Access Compliance Report

Public Rights-of-Way

(Curb Ramps)

Intersection ID: 15311	Main Street: ALBEMARLE_RD	Cross Street: DRIFTWOOD_DR	Location: NE
ADA ID: 3AB76F7F9645	Ramp Type: Para	Initial Pass/Fail: Fail	Overall Compliance: No
Codes/Mitigation Info/Possible Solution		Field Measurements/Component Compliance	
Severity Score: 21.25

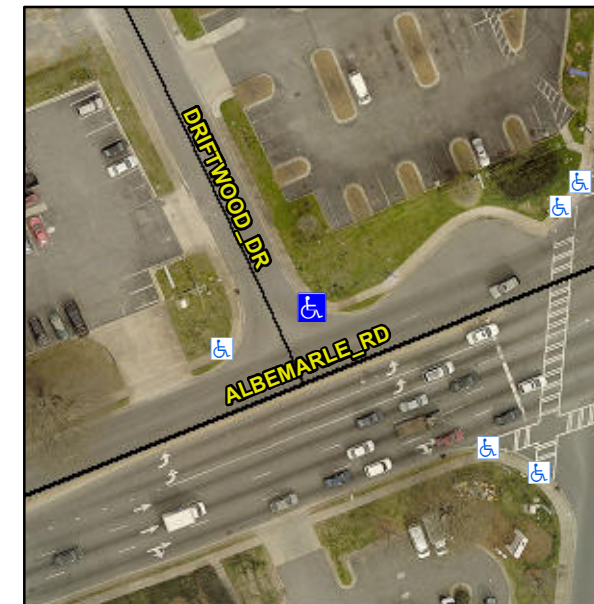
Surveyor Notes:

LT RP < 5%

PROW/ADA:

R304.5.1, R304.3.2

Possible Solutions:

Remove & Replace Entire Ramp.
